ADDENDUM NO. 2

Date: April 8, 2015

Project: Wardlaw Parking Lot Renovation
Project Number: H27-Z200

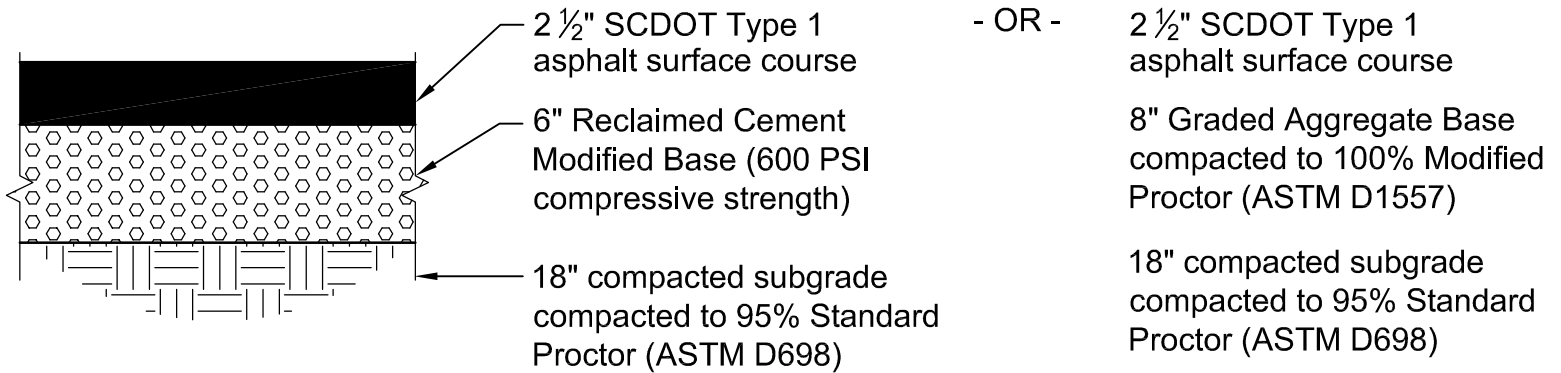
The following items were changed:

- The pavement sections have been revised to include the option of using GABC **or** cement stabilized base. All excavated material is unclassified and must be removed from the site and disposed of in a legal manner at the contractor's expense.
- Bidders are to include the cost of removal of the cedar tree located on the right side of the building as you look at the building from the driveway.

We will allow the use of GABC base course in lieu of the cement stabilized base. Please note the differences in asphalt thickness as well based on the type of base that is selected.

Heavy Duty Asphalt Pavement Section

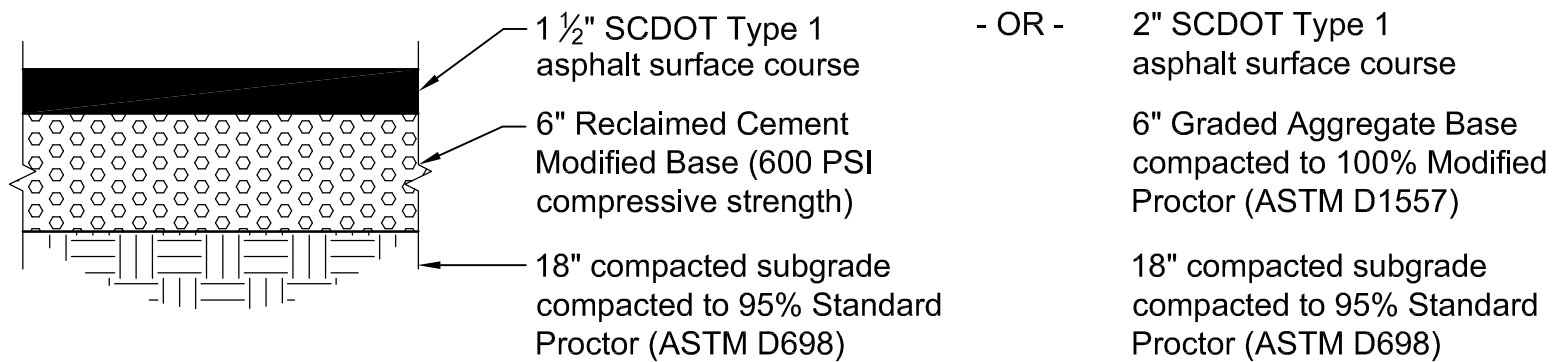
1. Reclaimed Cement Modified Base blending should be conducted in accordance with a minimum blend rate of 8% by weight of Type 1 or 3 cement, and the blend should achieve a required average compressive strength of 600 psi. The selected reclaimed materials should be collected and tested to determine the spread rate in pounds per square yard (psy) upon selection of the quarry.
2. All excavation is unclassified. All excess material shall be hauled off site and disposed of in a legal manner.
